ENGINEERING ORDER

1. ENGINEERING ORDER NO. 2011C1568-T

2. DWG TITLE	3. DWG CAGE CODE	4. DWG NO.
PRINTED WIRING ASSY VOLTAGE REGULATOR BD#1	99167	949F028

This EO adds Item Unique Identification (IUID) requirements to the drawing

PN 949F028-4 (REF)

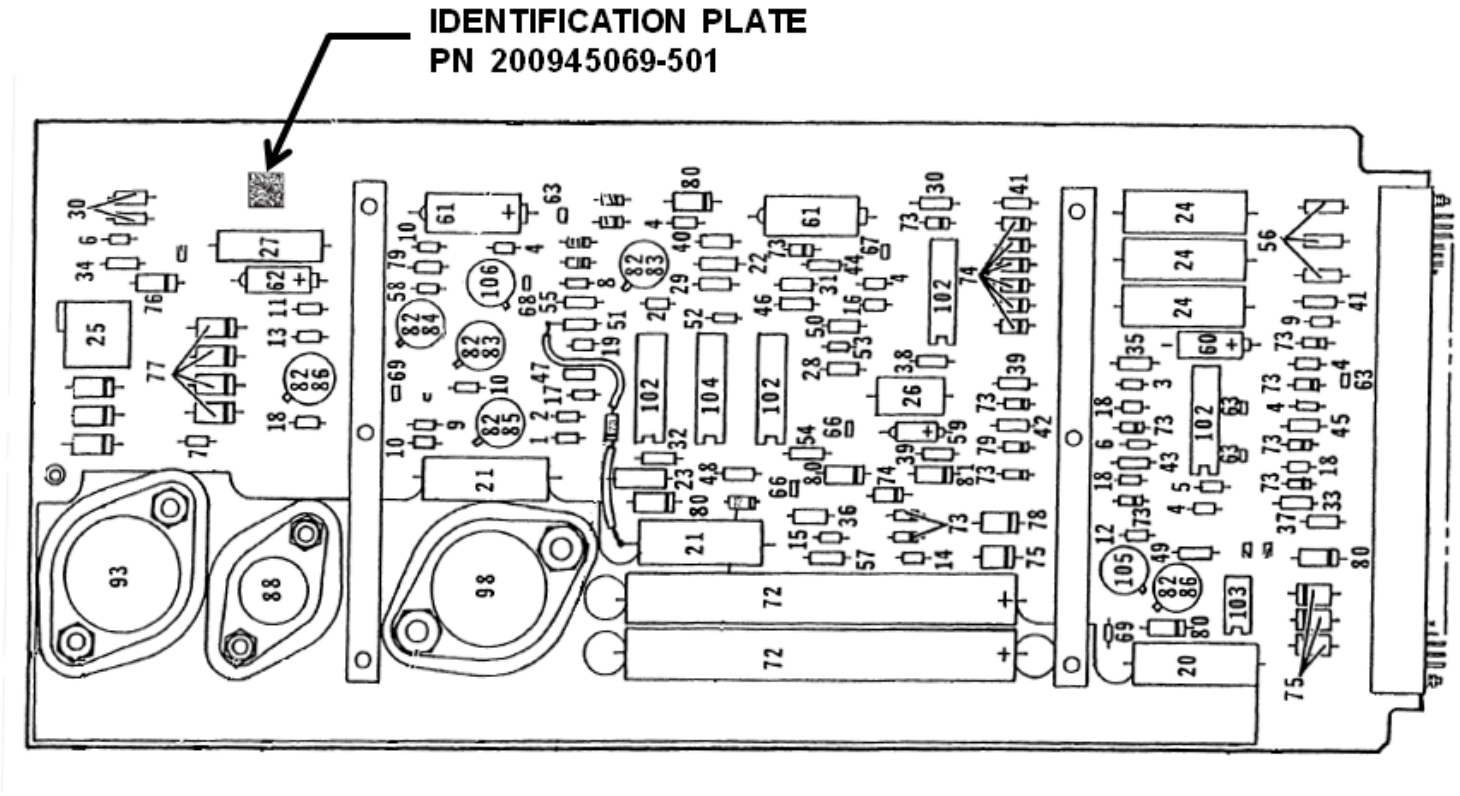
- If no UID label is present, fabricate new UID label (200945069-501) and attach to the front of card, near the edge opposite the connector end, and located near the "27" resistor. Do not cover any traces or solder joints.

- New UID label will be located on the end item as shown in sketch/photo on page 2, AF form 3926.
